Re: Linc Energy Ltd Class III Aquifer Exemption Request Underground Coal Gasification  
Demonstration Gasifier #6 Project Wyodak Coals - Fort Union Formation Campbell County,  
Wyoming

**AQUIFER EXEMPTION RECORD OF DECISION**

**Well/Project Name:** Underground Coal Gasification (UCG) Demonstration Gasifier #6 Project

**FIGURE 13.14-1: PROPOSED AQUIFER EXEMPTION AREA WITHIN NW 1/4, SEC 36, T44N, R74W**

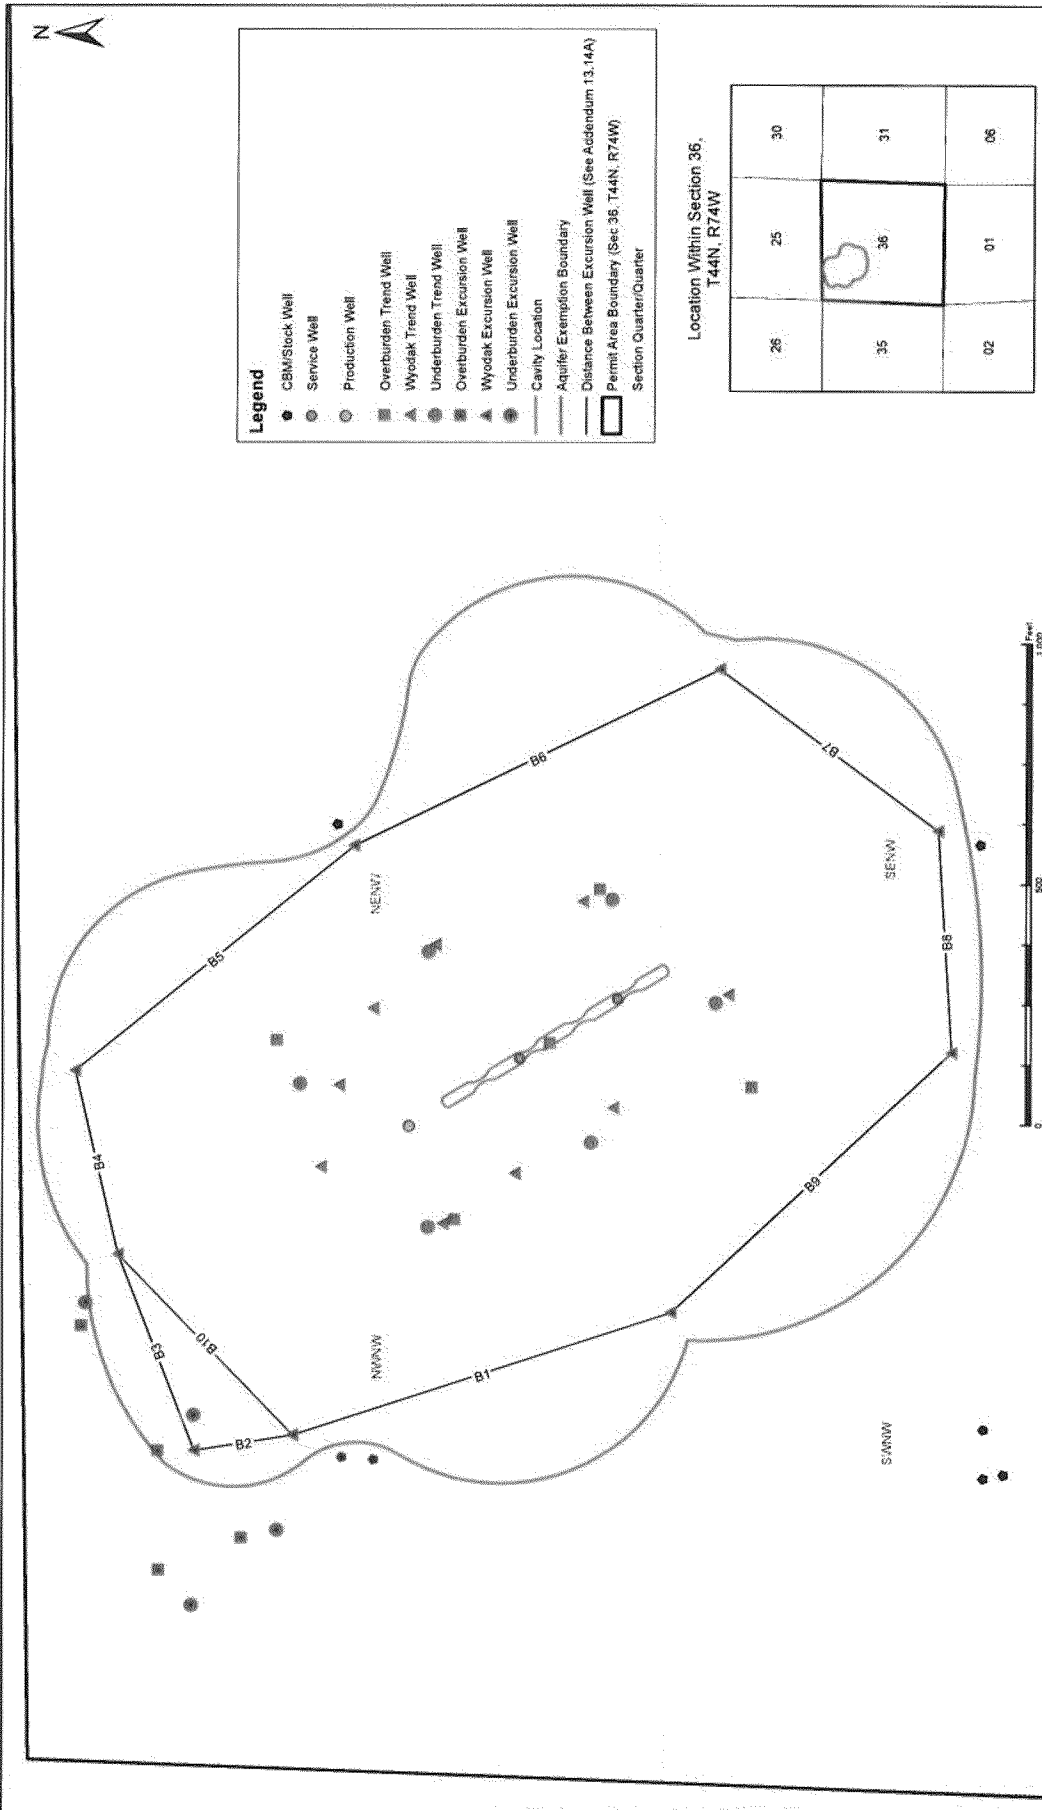
The Wyodak coals of the Fort Union Formation are located at an approximate depth of 1,100 feet below ground surface and are approximately 27 to 30 feet thick. This area is generally horizontally described by the excursion monitor well ring plus a distance approximately 144 feet beyond the monitor well ring as shown in the Record of Decision, Attachment 1 (Figure 13.14-1).

The area proposed for exemption is approximately 80 acres in the northwest part of Linc's lease (see Attachment 1, Figure 13.14-1) for the permitted research and development project.

The exempted area was determined based on the location of the excursion wells (EWs) plus a calculated distance beyond the EW perimeter. Based on experience gained at the Rocky Mountain I UCG demonstration project, the EWs are placed at the recommended minimum distance of 600 feet from the cavities to account for the "gasifier area of influence," a gasifier operations zone of elevated product gas concentration and pressure that commonly extends into the coal surrounding the gasifier cavity. Additionally, the fractured nature of coals provides a preferred pathway for gas migration and further supports the need for a large separation between the gasifier cavity and EWs. The calculated distance beyond the EW perimeter to the AE boundary is similar to methodology that has been adopted by uranium in-situ recovery operators in Wyoming applying for Class III permits. That distance was calculated to be 144 feet. Should an excursion be detected at an EW, this additional distance will allow Linc to detect and begin operational controls to bring the excursion under control before it reaches an adjacent USDW. The distance of the AE boundary is calculated to be approximately 744 feet from the gasifier.

The record indicates that commenters expressed concern that the AE boundary is not extensive enough to prevent contaminants from endangering USDWs. Similarly, concerns were raised regarding the derivation of the 144 feet from the EW perimeter to the AE boundary. The values that Linc used to calculate the AE boundary were conservative. First, Linc assumed an absence of inward hydraulic gradient towards the gasifier that will be maintained during gasification and restoration. In fact, there will be an inward hydraulic gradient during operation and restoration. Second, the travel time was calculated assuming a conservative substance that is not retarded as it moves with the groundwater. The contaminant of greatest concern are the hydrocarbons which will rapidly retard in the coal environment and will no longer be mobile. Therefore, both of these assumptions make the AE boundary calculation a conservative estimate and the AE area is appropriately sized for this UCG project.

In addition to the hydraulic containment favored by the existing hydrogeology at the site and Linc's planned operational controls, a robust monitoring plan will also be required to demonstrate the fluids remain within the exempted area. There are two sets of concentric monitoring well rings with the AE boundary found exterior to both (see Attachment 1, Figure 13.14-1 of the application).

**APPROVAL OF PROPOSED AQUIFER EXEMPTION:** Based on review of the supporting information provided by the WDEQ, and pursuant to 40 CFR §144.7(b)(3), the EPA hereby approves a non-substantial program revision (see 40 CFR §§144.7 & 145.32) to include exemption of a portion of the Wyodak coals in the Fort Union Formation. The aquifer exemption area is depicted in Attachment 1 (Figure 13.14-1) of the Record of Decision. The depth and extent of the aquifer exemption is as follows:

Based on review of the entire record, the EPA finds that exemption criteria 40 CFR § 146.4(a) and 146.4(b)(1) have been met and the EPA approves the AE request as a non-substantial program revision.
